Gegenstand : Zylinderfußdichtung  
Subject : Cylinder-base-gasket

Betroffen/Applicability : Motoren/engine Solo 2625 eingebaut/installed in:  
Typ/type: DG-500, DG-800  
Baureihen/variants DG-800B, DG-808C, DG-500MB

Photo 1

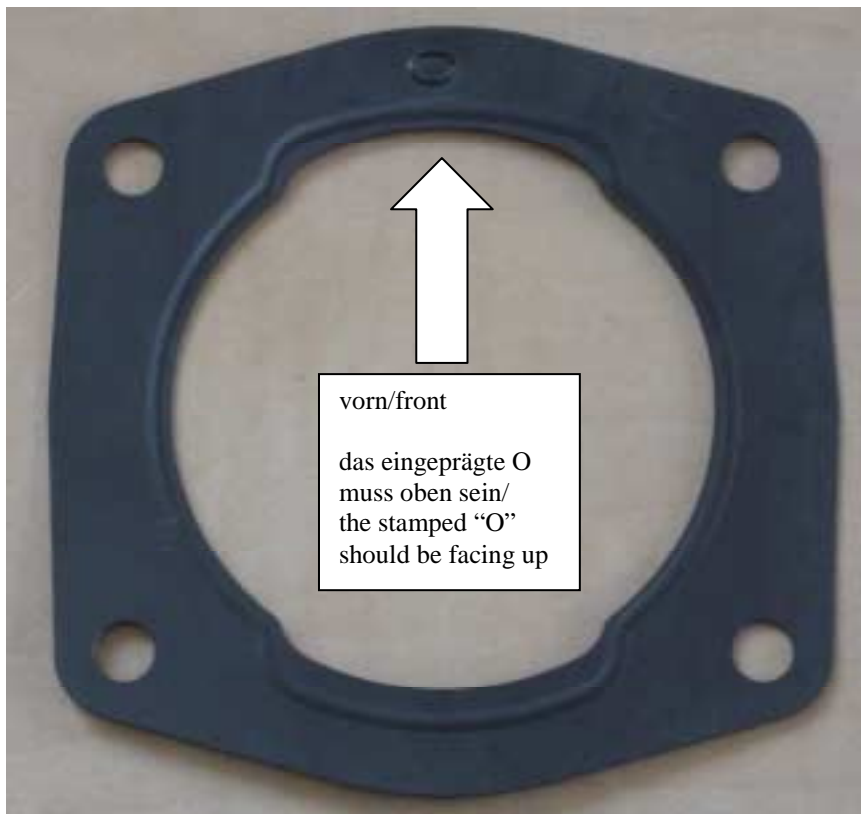
Vorgang : Die Fa. Solo hat neue verbesserte Zylinderfußdichtungen entwickelt.  
Reason : The Solo company has developed new improved cylinder- base -gaskets.

Massnahmen : 1. Ev. vorhandene Dichtungen, die nicht dem Foto 1 entsprechen, dürfen  
Instructions : nicht verwendet werden.  
2. Prüfen, ob die Zylinderfußschrauben gemäß Foto2 (eingeschnürt)  
ausgeführt sind. Ansonsten auch die Zylinderfußschrauben austauschen.  
1. Don't use cylinder- base -gaskets which you may have on stock other  
than shown in picture 1 below.  
2. Check if the cylinder base studs are of newer necked down design, see  
photo 2. If not, replace the studs by the latest design

Material: DG Bestellnr./DG part no.:  
60500232 Zylinderfußdichtung /cylinder- base -gaskets  
60500180 Dehnschraube Zylinderfuß / necked down cylinder base stud
